**PCN#20181205001.0**

**Pin One Dot Symbolization change – Adding Pin One Dot for Select SC70, SOT-23,  
and SOT-223 Devices  
Information Only**

Current Symbolization (No Pin One Dot)	New Symbolization (With Pin One Dot)
<b>SC70 Example</b>		
<b>SOT-23 3 Lead example</b>		
<b>SOT-23 5 Lead example</b>

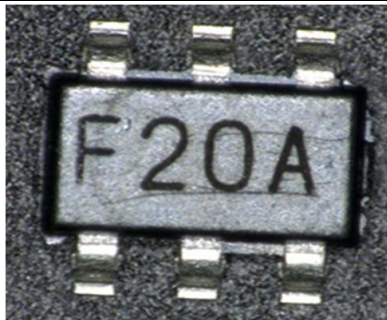
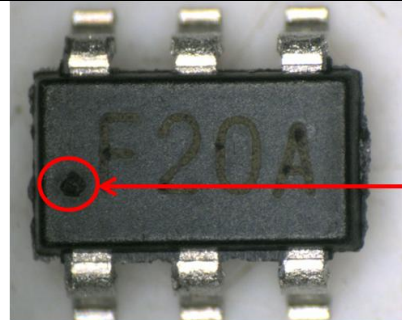
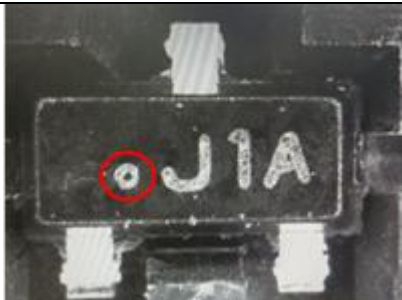
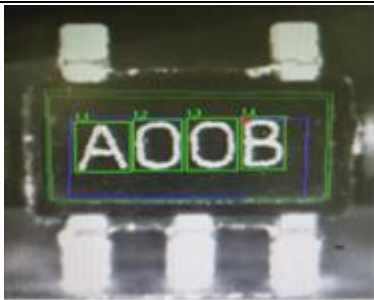
This letter is to inform of the addition of a Pin One dot in the devices symbolization of select SC70, SOT-23, and SOT-223 Devices:
